INFORMATION LETTER

20 August 2020

SUBJECT: MAIN TRANSMISSION SUPPORT CASE MOUNTS, NEW INSPECTION REQUIREMENTS.

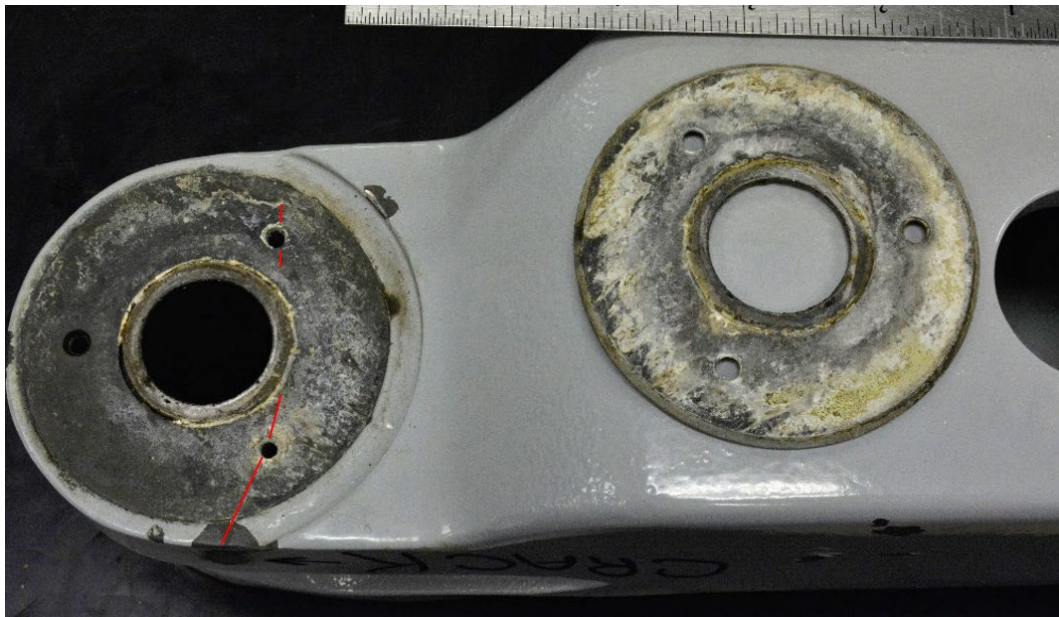
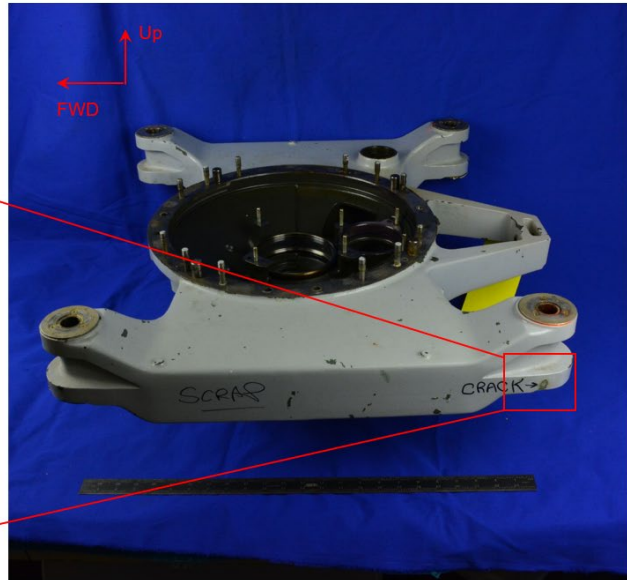
Bell occasionally receives reports of main transmission support cases found cracked at one of the lateral mounts. Cracking is usually caused by excessive corrosion of the surface under the washer and originates from a washer attachment screw threaded hole. Cracking can occur at the upper or lower surfaces of the lateral mount. The pictures on Page 2 show an example of a case found cracked during routine maintenance. To mitigate the risk of cracking due to corrosion, this Information Letter (IL) informs owners/operators of a new support case inspection requirement that has been incorporated in the Maintenance Manual (MM).

At the interval specified by the latest manual revision, the washers installed on the upper and lower surfaces of the support case lateral mounts must be removed to inspect the area in accordance with the latest criteria. The Component Repair & Overhaul Manual (CR&O) has also been revised to include washer removal and installation instructions as well as corrosion damage limits for the affected area.
